Office Action Summary

10/821,860

CABRELE, FEDERICO

DETAILED ACTION

Fig. 12

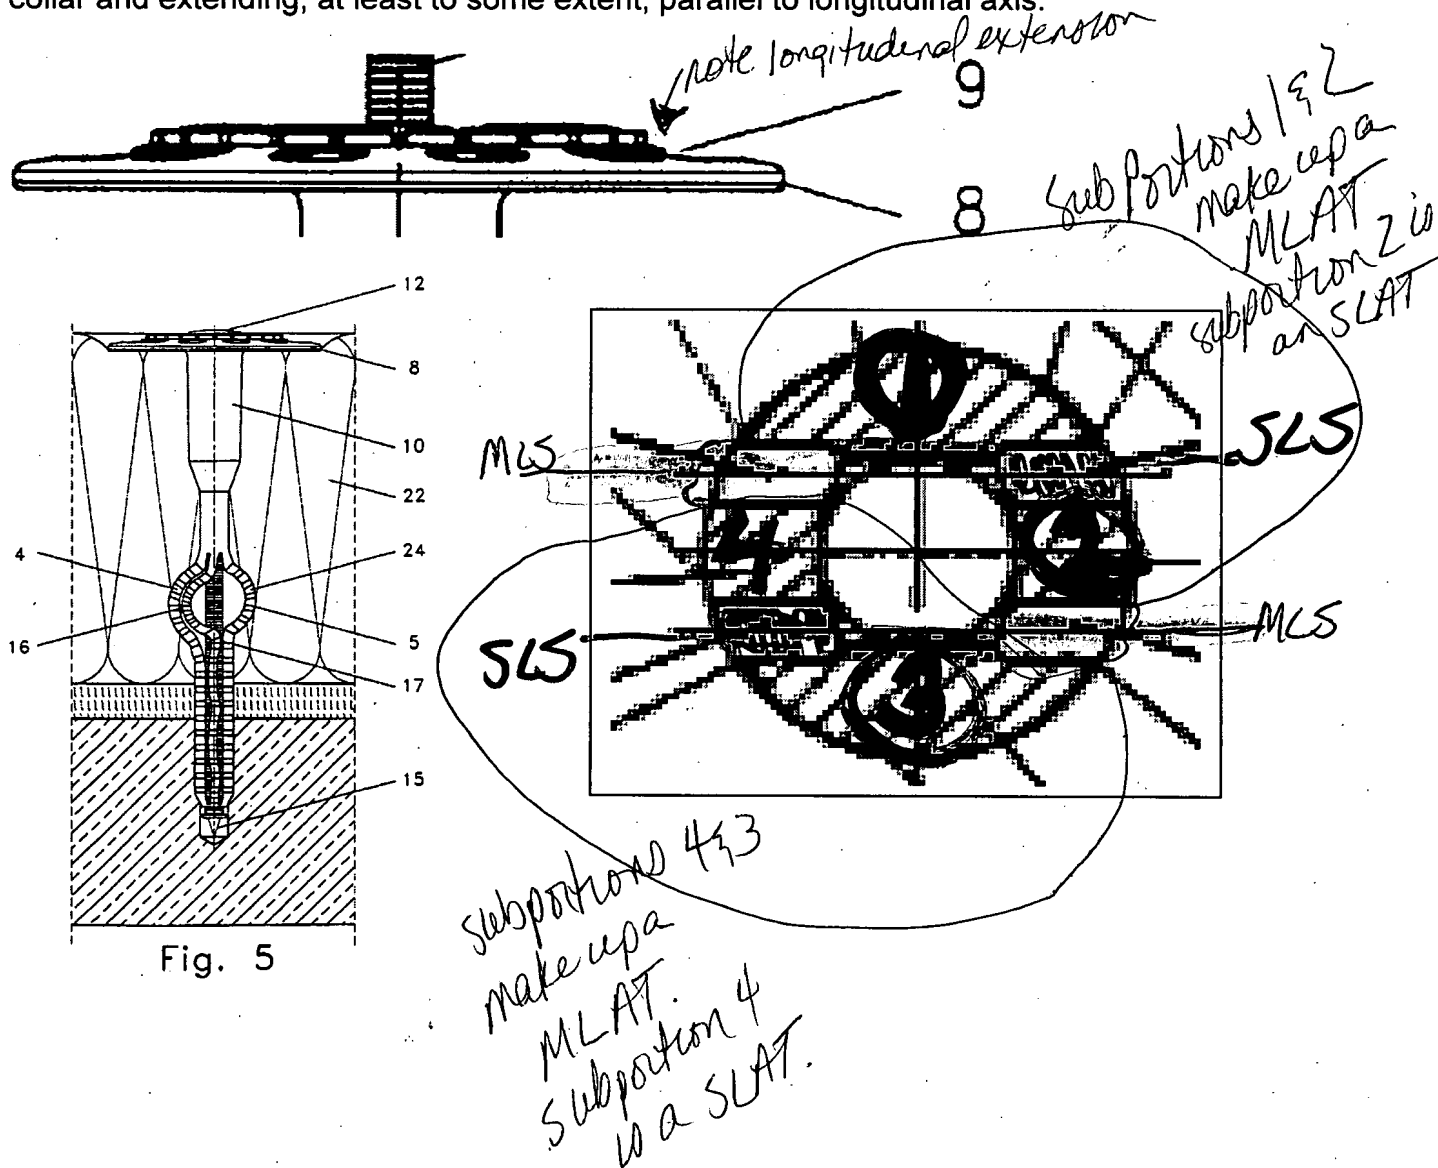
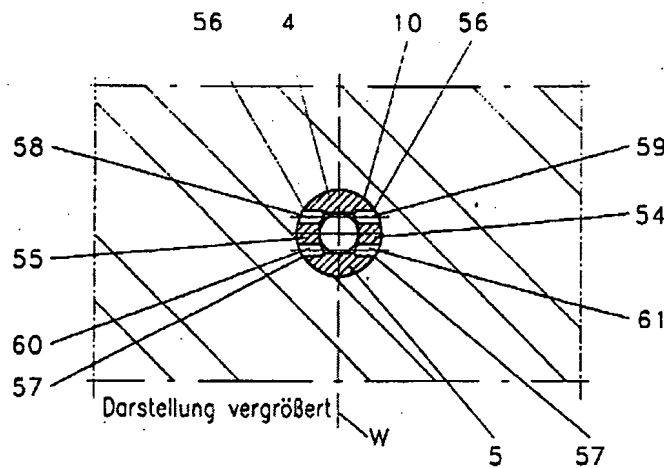
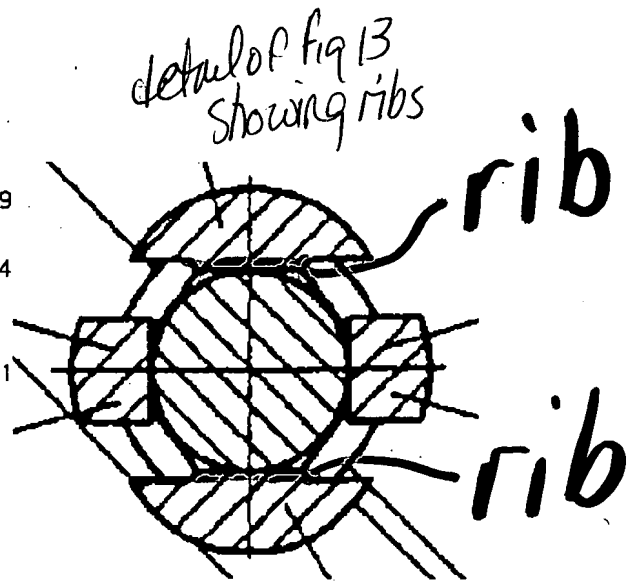
Re claim 10: "10" is considered the collar, and Fig 5 shows the collar with an annular flange "8".

Re claim 11: Fig 1 (detail below) shows projecting appendices 9 integral with collar and extending, at least to some extent, parallel to longitudinal axis.

Re 12: Portion at end near "15" in Fig 5 is considered a head at 2nd end.

Re 13: There is a coaxial through hole. There are internal longitudinal ribs (see detail of cross sectional cut, ^{Fig 13} above, extending into hole.

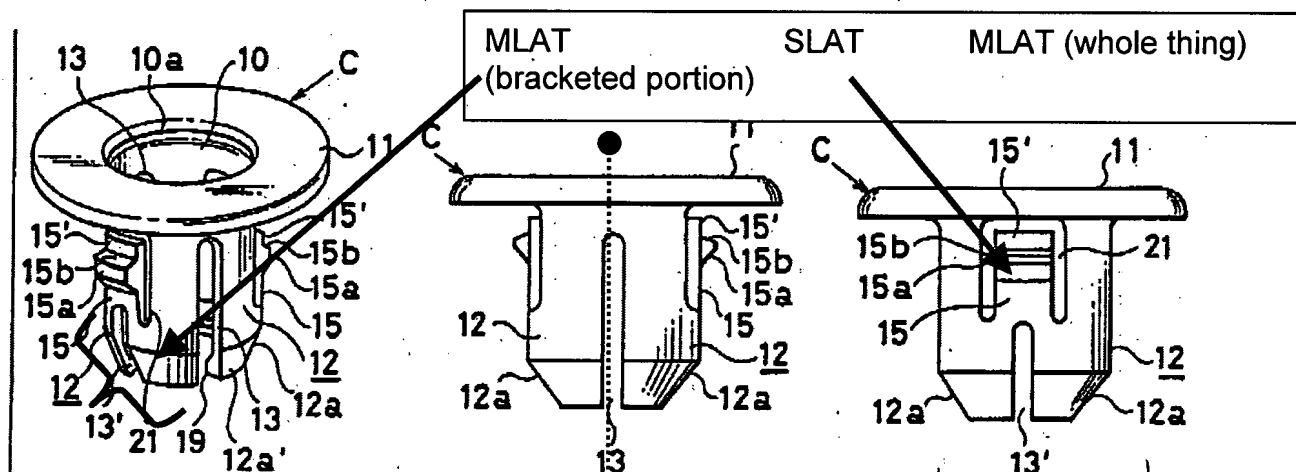
- 106 teaches a screw anchor comprising main longitudinal tongues (entire side shown in Fig 4)

axis/plane
into/out of page

this is one MLAT.
A SLAT is formed
by SL5 "21"

As Fig 3 (middle figure above) shows, the MLATs are diametrically opposite each other with respect to a longitudinal axis of the anchor. SLATs are arranged in pairs (1 SLAT forms a pair with the other SLAT to form a pair of diametrically opposed SLATs, and each respective SLAT is arranged with (surrounded by) the respective MLAT that surrounds it to form a pair of tongues on the same side of the axis. Each SLAT is shorter than and narrower in width than each MLAT.

Re 15: MLATs are separated by MLS (13 (not 13')) which extend essentially parallel to a plane on which the screw anchor longitudinal axis lies, and the MLATs lie on opposite sides of the plane (Plane drawn by examiner on Fig 3 above is a plane going into and coming out of the page, and this plane includes anchor longitudinal axis)

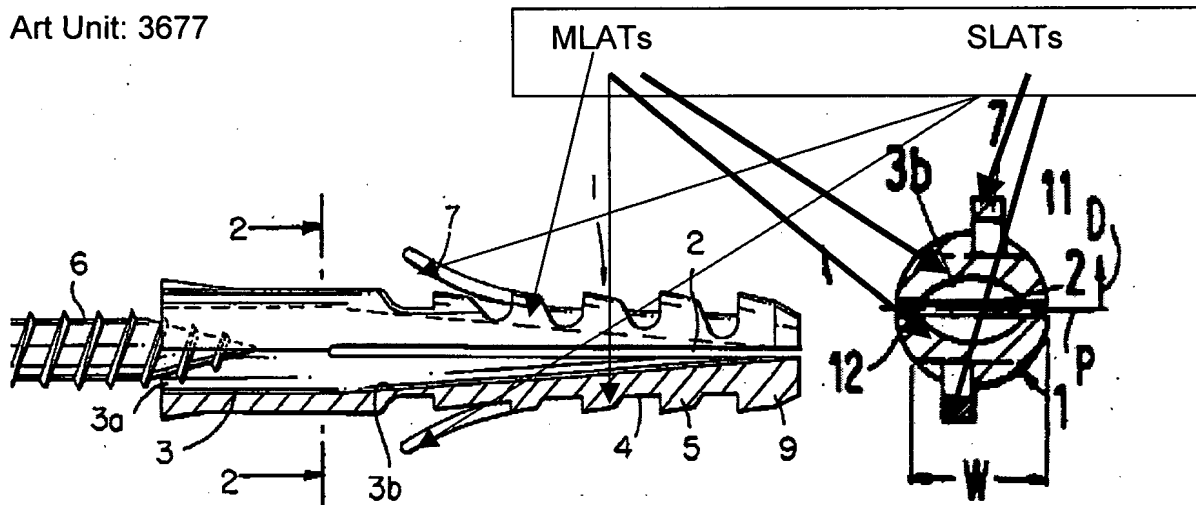
- Fischer teaches a screw anchor comprising main longitudinal tongues (MLATs) with the MLATs are diametrically opposite each other with respect to a longitudinal axis of the anchor. (MLATs are each the two halves formed by longitudinal slot 2) SLATs 7 are arranged in pairs (1 SLAT forms a pair with the other SLAT to form a pair of opposed SLATs, and each respective SLAT is arranged with (surrounded by) the respective MLAT that surrounds it to form a pair of tongues on the same side of the axis. Each SLAT is shorter than and narrower in width than each MLAT.

Re 15: MLATs are separated by MLS (2) which extend essentially parallel to a plane on which the screw anchor longitudinal axis lies, and the MLATs lie on opposite sides of the plane
